46820 Magellan Drive Parking Lot Expansion JSP12-66

Consideration of the request of Carrier Real Estate, LLC, for Preliminary Site Plan and Stormwater Management Plan approval. The subject property is located in Section 9 at 46820 Magellan Drive, south of West Road and east of Beck Road in the I-1, Light Industrial District. The subject property is 3.06 acres and the applicant is proposing to add 20 parking spaces to the site by eliminating existing grass areas and relocating existing landscaping.

PLAN REVIEW CENTER REPORT

**SUBJECT: Parking Lot Expansion, 46820 Magellan Drive (3.06 acres),
JSP12-0066, PSP12-0036, Traffic Review of Preliminary and
Final Site Plan**

Attachment: Aerial photo

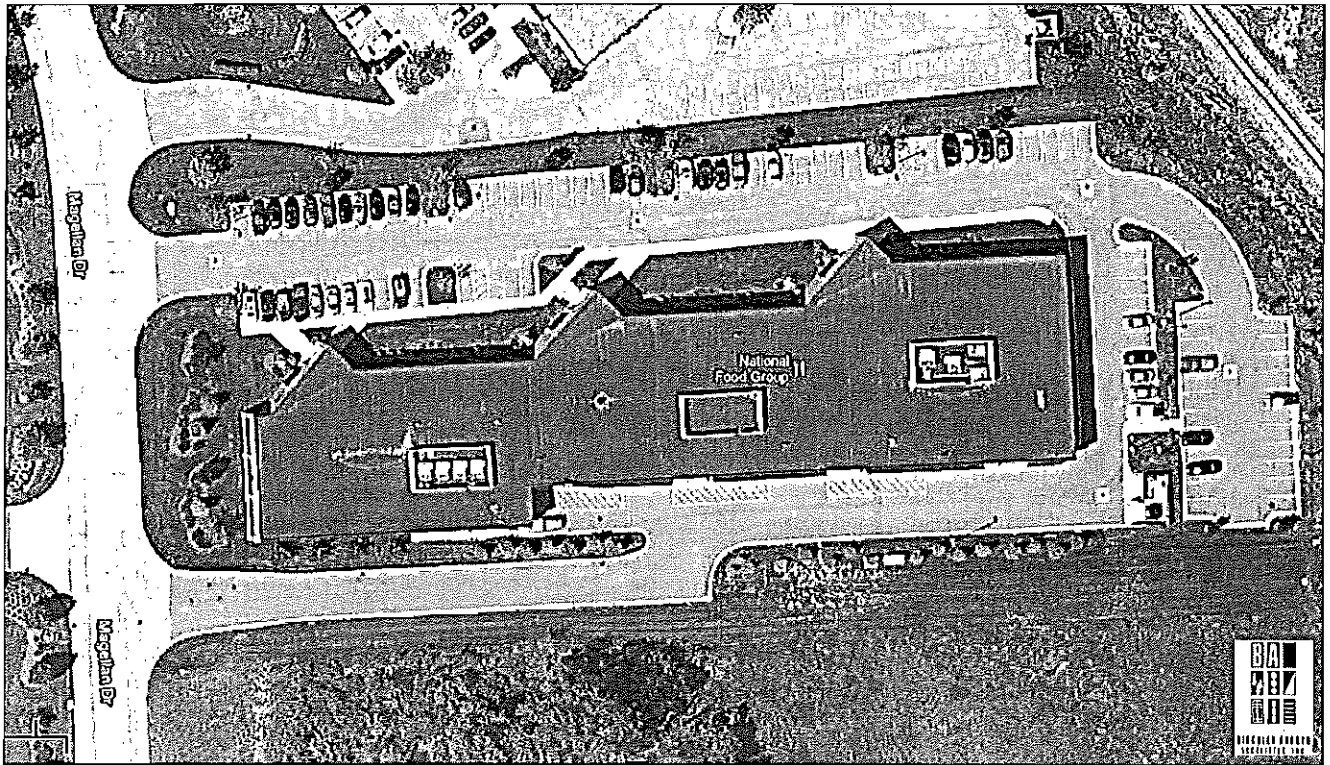
7. **The proposed use of painted end islands for the new eight-space parking module near the south property line requires a Planning Commission waiver of Section 2506.13 of the Zoning Ordinance.** We support the needed waiver, as raised islands in these locations are not functionally needed (the spaces involved are too small to accommodate improperly parked vehicles). As the island crosshatching is meant to deter parking in the marked areas, the proposed use of yellow is appropriate.

8. The angled parking spaces cited in the preceding comment have been dimensioned 18 ft long on the architectural plan but 19 ft long on the engineering plans, both incorrectly referenced to the back rather than face of a proposed new 4-inch-high curb. The City standard length for an acute-angled parking space is 18 ft, not 19 ft, and similar to a 90-degree parking layout, a 2-ft overhang of a 4-inch curb is expected. Hence, **the stall striping should be shortened to 16 ft, referenced (as all parking should be) to face of curb. Also, for compliance with the MMUTCD, the striping for these and all other new non-barrier-free parking spaces must be white, not yellow** (per the attached aerial photo, this would also be consistent with the color of existing parking space striping). Finally, the architectural site plan contains a note (#8) indicating that a 15-ft-wide maneuvering lane is required adjacent to 53-degree angled parking. We believe, instead, that the Zoning Ordinance should be interpreted as requiring an aisle width interpolated between the 15-ft and 18-ft widths listed for 45-degree and 60-degree parking, respectively, or in this case, a minimum aisle width of 16.6 ft; note that such would be more-than-provided by our proposed striping length.

9. To further comply with the MMUTCD, the striping, pavement arrows, and **ONE WAY** messages proposed to delineate the 15-ft-wide eastbound-only travel lane should be white, not yellow. The pair of opposing-direction pavement arrows shown in the east parking aisle should also be white. In correcting the colors of the pavement markings on detail sheet C-5.1, we further recommend that the space between the words **ONE** and **WAY**, and between **ONE** and the arrow, be increased (for readability) to at least 1.5 ft.

7. We understand that the use of striped islands will require a Planning Commission waiver. If granted, the color of the island striping will be yellow.

8. Dimension of the parking spaces shall be adjusted (thus increasing the width of the maneuvering lane) and the striping of those spaces shall be white.
9. Pavement marking indicating one-way traffic movement will be adjusted accordingly.
10. The required "No Parking – Loading Zone" signage will be adjusted accordingly.
11. The sign mounting height on Sheet C-5 shall be corrected.
12. General Note 1 shall be revised to indicate that parking spaces are measured to face of curb.
13. The pavement markings at the barrier free space shall be painted the colors as noted in the review.

Architectural Site Plan
 12-124

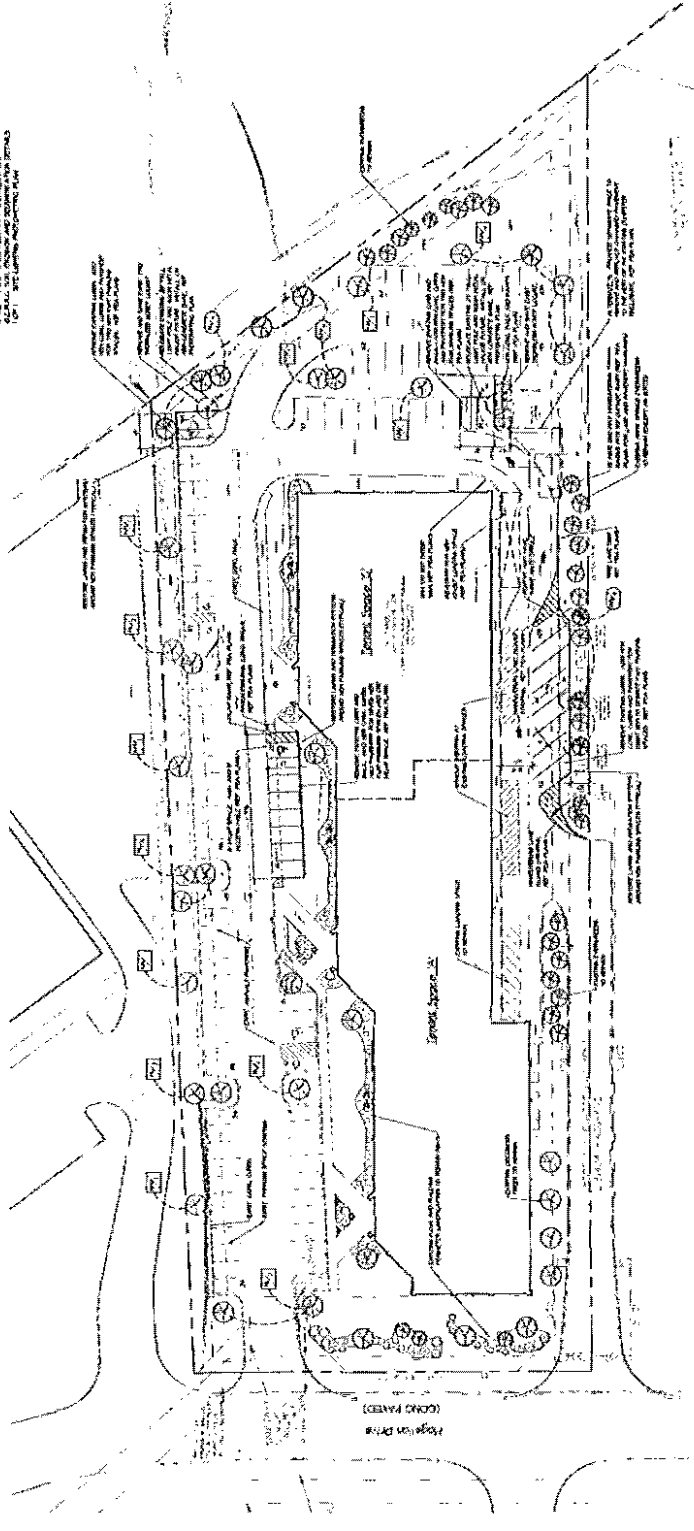
2. Clarify what "Alternative #1" (remove and replace pavement west of dumpster enclosure) is a substitute for and when it may be used.

1. The required calculations shall be provided.
2. Sheet A1.1 indicates what Alternate #1 is. For clarification: there is an area west of the existing dumpster enclosure where the existing asphalt pavement has become rutted. We are asking bidders to provide a separate price to remove and replace the asphalt in this area so that our Client can determine whether to proceed with the repair work or not.
3. The required letter shall accompany the revised Final Site Plan documents
- 4.-11. Items are to be addressed by the contractor prior to construction.
